To: T10 Technical Committee  
From: Barry Olawsky, HP ([barry.olawsky@hp.com](mailto:barry.olawsky@hp.com)) and  
Rob Elliott, HP ([elliott@hp.com](mailto:elliott@hp.com))  
Date: 2 December 2004  
Subject: T10/04-337r2 SAS-1.1 TCTF Editorial Changes

**Figure 51 — Compliance interconnect-TCTF test load**

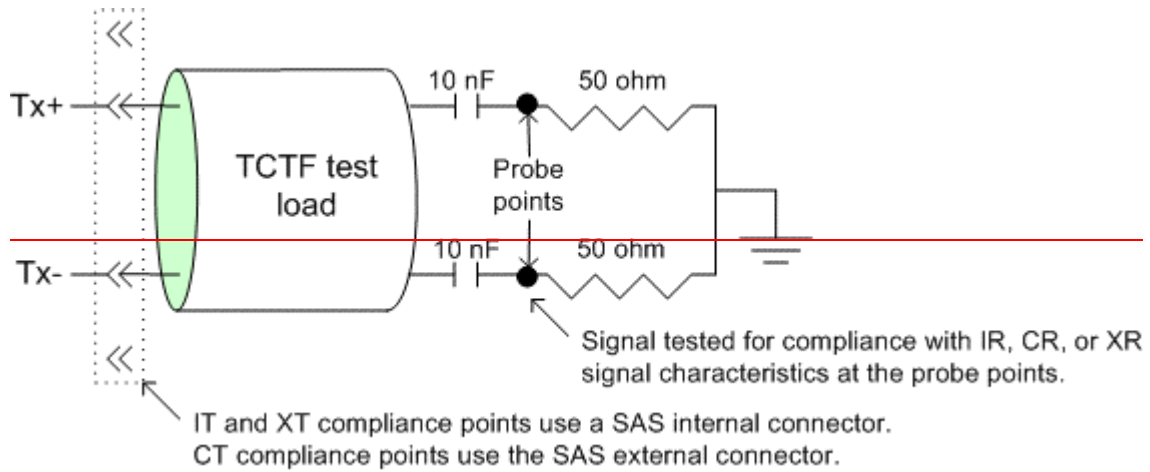
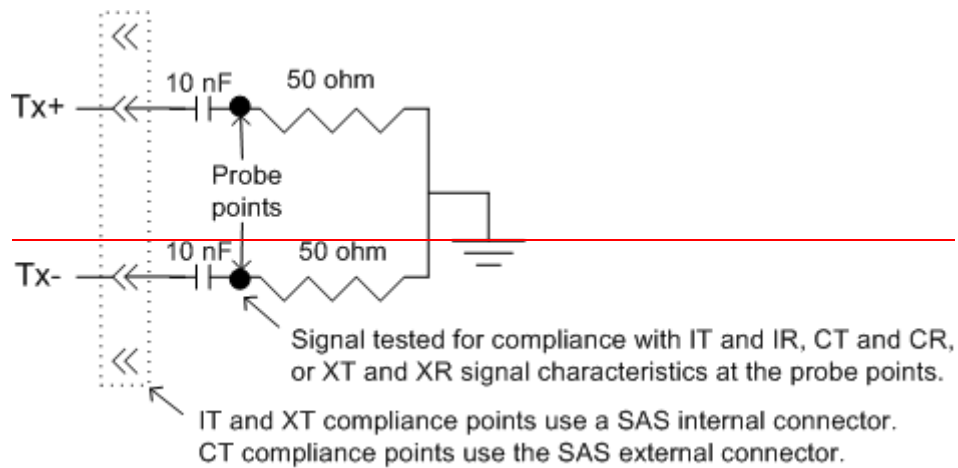
Compliance with the TCTF test load requirement shall be determined by measuring the signal produced by the transmitter through a physical ~~compliance interconnect~~ TCTF test load attached to the transmitter compliance point (i.e., IT, CT, or XT) as shown in figure 51.

Figure 51 shows the ~~compliance interconnect~~ TCTF test load. Physical positions are denoted as 'probe points' in several of the figures in this clause. Probe points identify the position in the testing procedures where the signal properties are measured but do not imply that physical probing is used for the measurement. Physical probing may be disruptive to the signals and should not be used unless verified to be non-disruptive.

**Figure 52 — Zero-length test load**

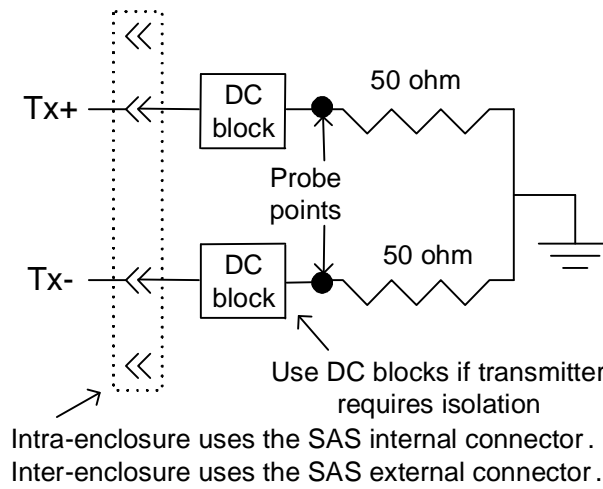
Compliance with the zero-length test load requirement shall be determined by ~~measurement made across measuring the signal produced by the transmitter through~~ a load equivalent to the zero-length load attached to the transmitter compliance point (i.e., IT, CT, or XT) as shown in figure 52.

Figure 52 shows the zero-length test load.

Figure 53 — ~~ISI loss example~~ TCTF  $S_{21}$  and ISI loss requirements at 3,0 Gbps

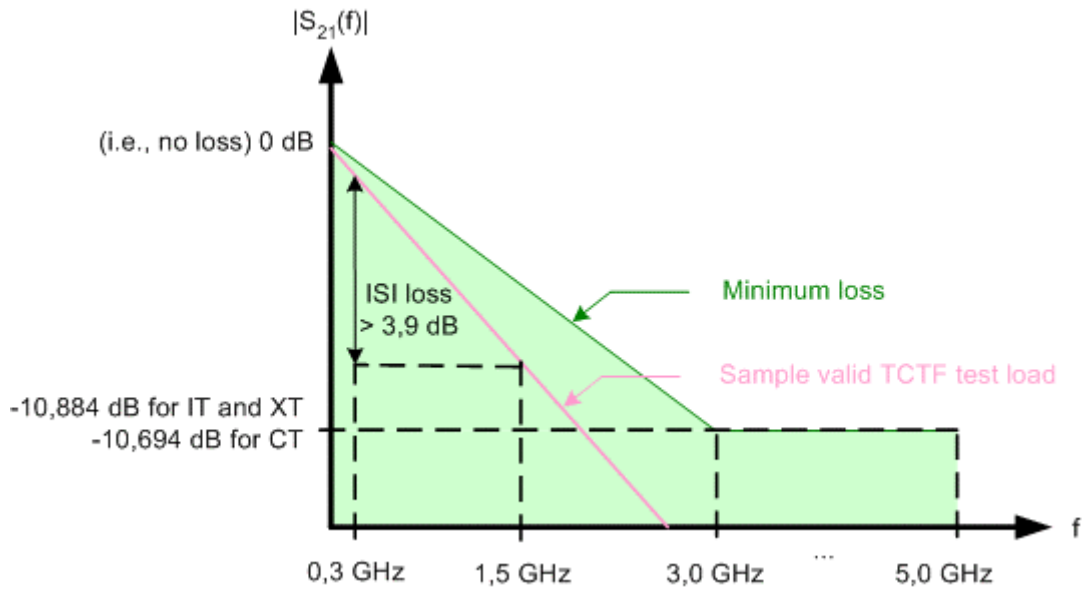
Figure 53 shows ~~an ISI loss example~~ the allowable  $|S_{21}(f)|$  and minimum ISI loss of a TCTF test load and the  $|S_{21}(f)|$  of a sample TCTF test load at 3,0 Gbps.

[Note to editor – Generate separate graphs for IT/XT and CT since the CT line is not straight.]

Figure 54 — ~~ISI loss example~~ TCTF  $S_{21}$  and ISI loss requirements at 1,5 Gbps

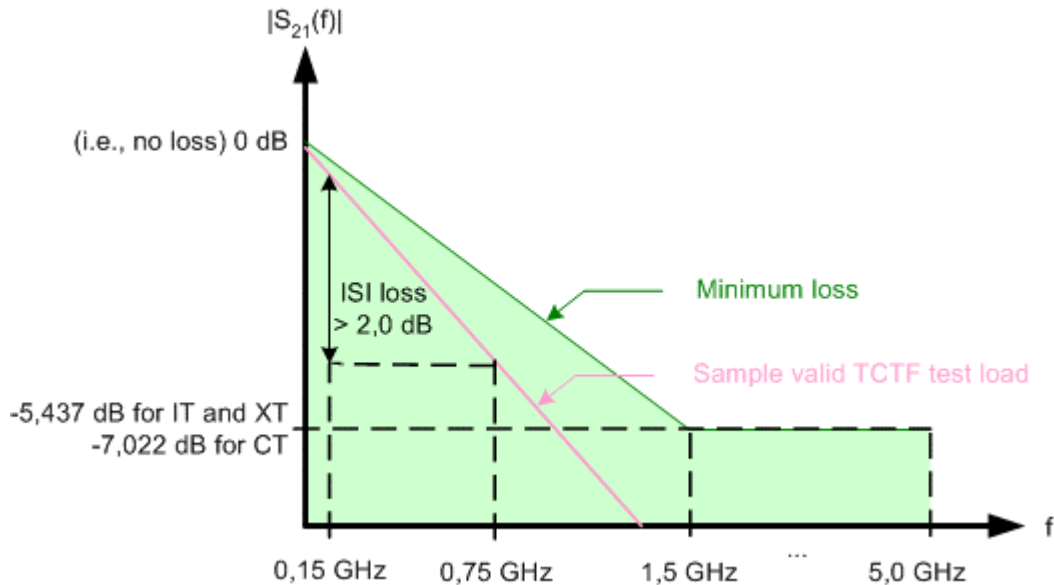
Figure 54 shows ~~an ISI loss example~~ the allowable  $|S_{21}(f)|$  and minimum ISI loss of a TCTF test load and the  $|S_{21}(f)|$  of a sample TCTF test load at 1,5 Gbps.
